**REQUEST**

Current Zoning: R-3 (residential)  
Proposed Zoning: R-8MF (CD) (multi-family residential, conditional)

**SUMMARY OF PETITION**

The petition proposes to rezone approximately 41.5 acres to a conditional multi-family district to permit the construction of up to 200 single family attached dwelling units at a density of 4.81 dwelling units per acre (DUA).

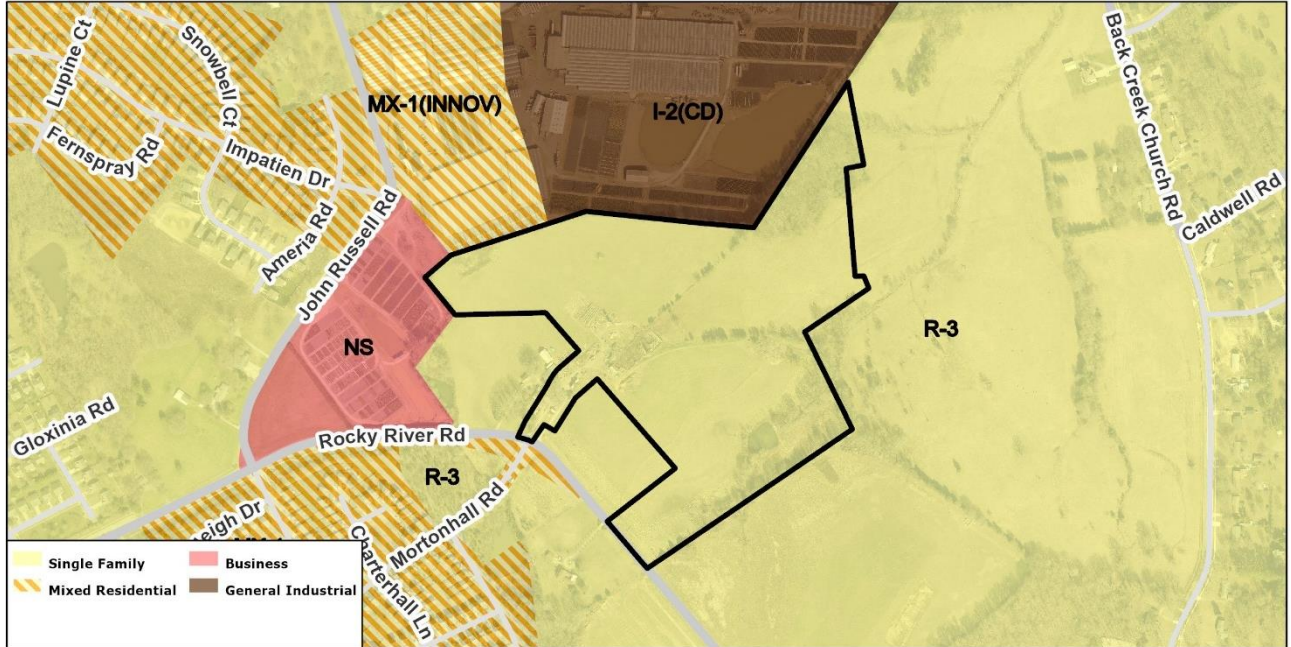
1. Correct acreage for Tree Save on Sheet 1. Acreage should be .97 and 150 percent of that number results in 1.305 acres replanted.

2. Remove "reverse frontage buffer" from legend as it no longer exists on the plan.
  3. List only the minimum required open space on the plan on both Sheet 1 and 2.
  4. Add ½ 100' Class A buffer label along the eastern portion of the rezoning boundary.
  5. Clarify why buffers are notched along the site's northern rezoning boundary. Reduction only allowed with construction of berm.
  6. Clarify whether driveway access from Rocky River is being dedicated as ROW. If not, buffers will be required.
  7. For note IV.8, replace "should" with "shall" or remove note in its entirety.
  8. Rename "lead walks" to sidewalks or a term more familiar to the review team.
-
